Access Compliance Report

Public Rights-of-Way

Intersection ID: 5507	Main Street: GIBBON_RD	Cross Street: HORACE_MANN_RD	Location: W
ADA ID: 2E3808D5CBA1	Ramp Type: Perp	Initial Pass/Fail: Fail	Overall Compliance: No
		Severity Score: 12.5

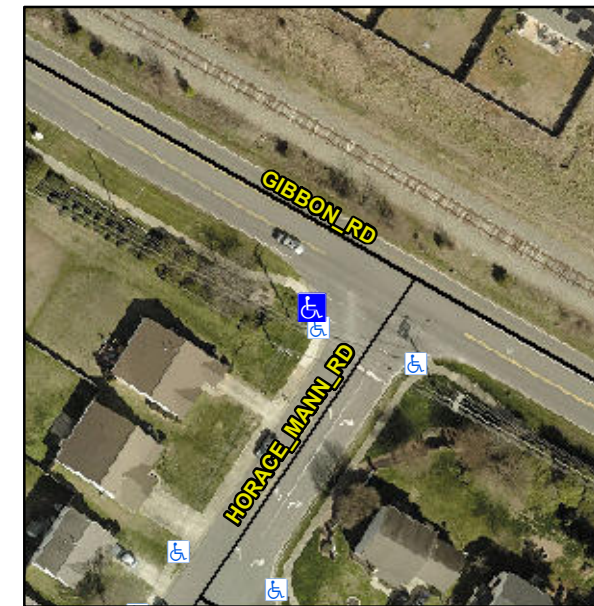
Not Found, R304.2.2

Compliance	Description	Data	Compliance	Description	Data
N/A	Ramp Length (in)	62.0	No	Ramp Slope (%)	8.6
Yes	Ramp Width (in)	48.0	Yes	Ramp XSlope (%)	0.7
N/A	Flare Type LT	N/A	N/A	Flare Type RT	N/A
N/A	Flare Slope LT (%)	N/A	N/A	Flare Slope RT (%)	N/A
N/A	Flare Traversable LT?	N/A	N/A	Flare Traversable RT?	N/A
N/A	Landing Length (in)	N/A	N/A	DWS Provided?	N/A
N/A	Landing Width (in)	N/A	N/A	DWS Contrast?	N/A
N/A	Landing Slope (%)	N/A	N/A	DWS Length (in)	N/A
N/A	Landing X Slope (%)	N/A	N/A	DWS Full Width?	N/A
N/A	Landing Curb? (Y/N)	N/A	N/A	DWS Offset (in)	N/A
N/A	Shared Landing?	N/A			
N/A	Gutter Ponding?	N/A	N/A	Gutter Slope (%)	N/A
N/A	Gutter Lip Ht (in)	1.0	N/A	Gutter X Slope (%)	N/A
N/A	Painted X Walk1?	Yes	N/A	Painted X Walk2?	N/A
	X Walk 1 Direction	To SE		X Walk 2 Direction	N/A
N/A	X Walk 1 Width (in)	111.0	N/A	X Walk 2 Width (in)	N/A
	X Walk 1 Slope (%)	0.9		X Walk 2 Slope (%)	N/A
	X Walk 1 X Slope (%)	1.3		X Walk 2 X Slope (%)	N/A

Remove & Replace Entire Ramp.
